Re: Response to Transportation Peer Review
Proposed Multifamily Residential Development – 592 Washington Street
Wellesley, Massachusetts

Vanasse & Associates, Inc. (VAI) is providing responses to the follow-up comments that were identified in the January 23, 2026 *Transportation Peer Review* letter prepared by Tighe & Bond (T&B) concerning their review of the November 2025 *Transportation Impact Assessment* (the “November 2025 TIA”) that was prepared by VAI in support of the proposed multifamily residential development to be located at 592 Washington Street in Wellesley, Massachusetts (hereafter referred to as the “Project”). Listed below are the comments that were identified by T&B in the subject letter followed by the response from the appropriate Project team member on behalf of the Project proponent.

Figure TA-1

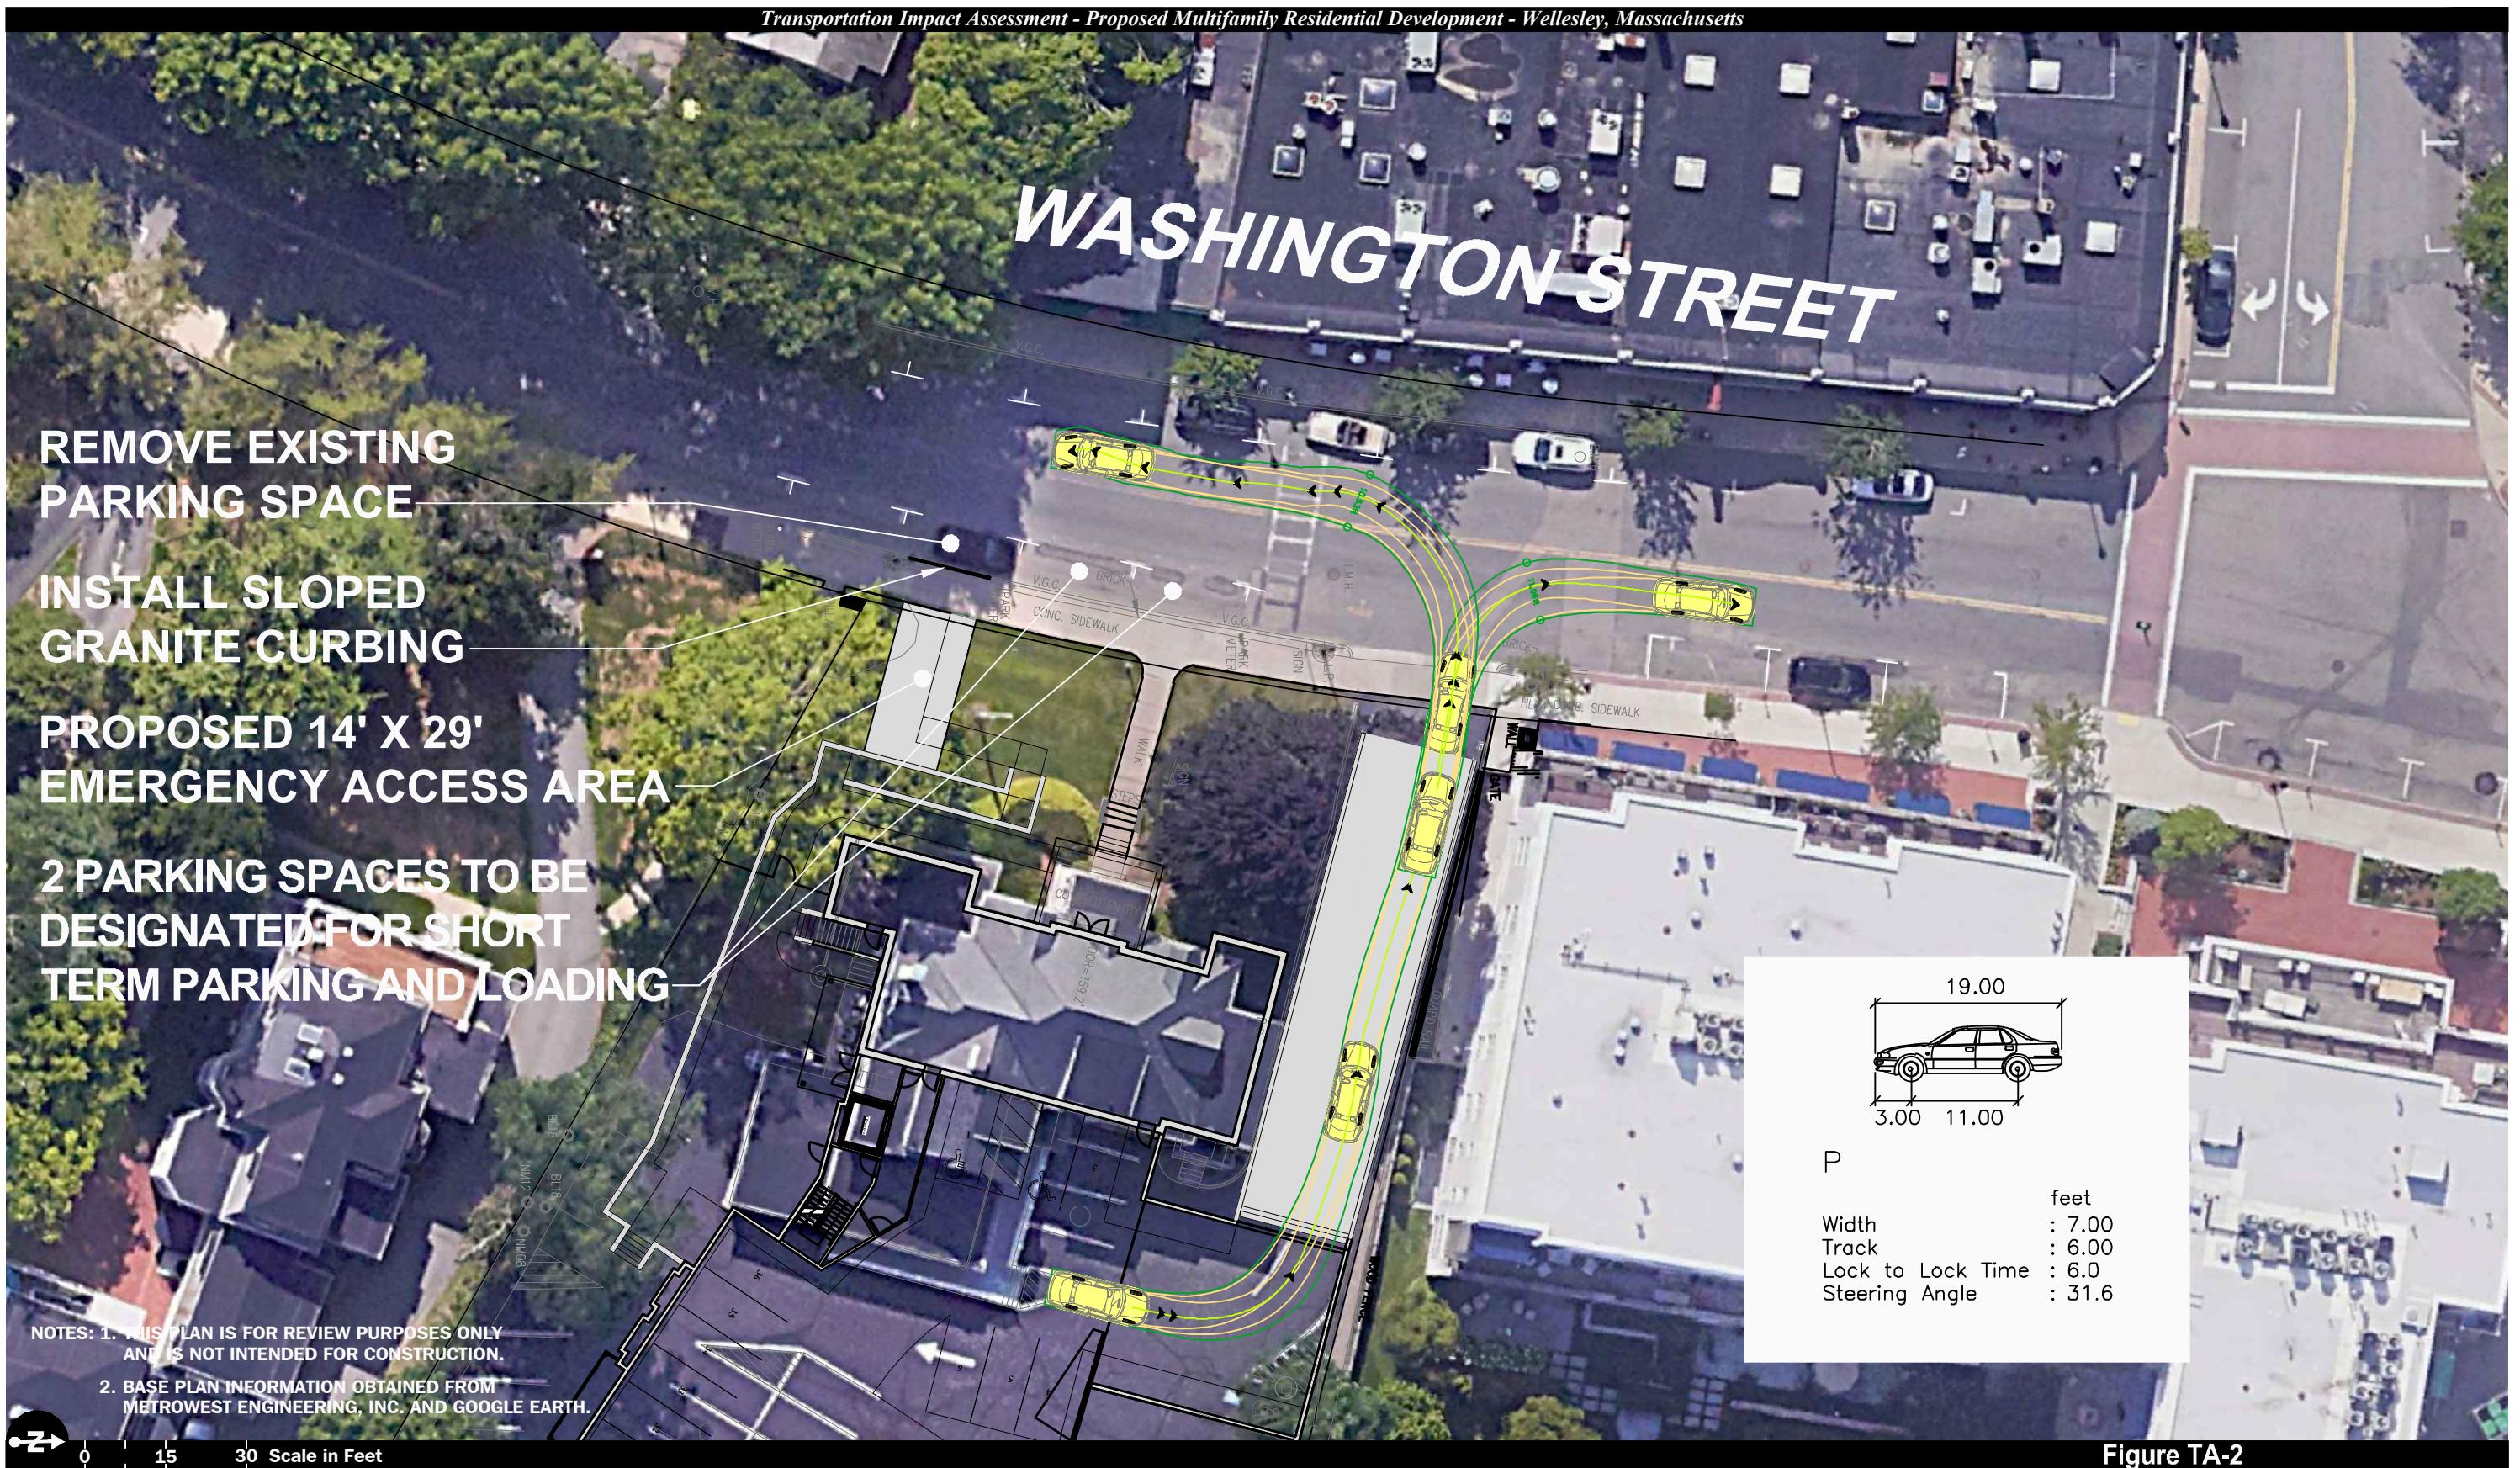
T&B Comment 10:

Response:
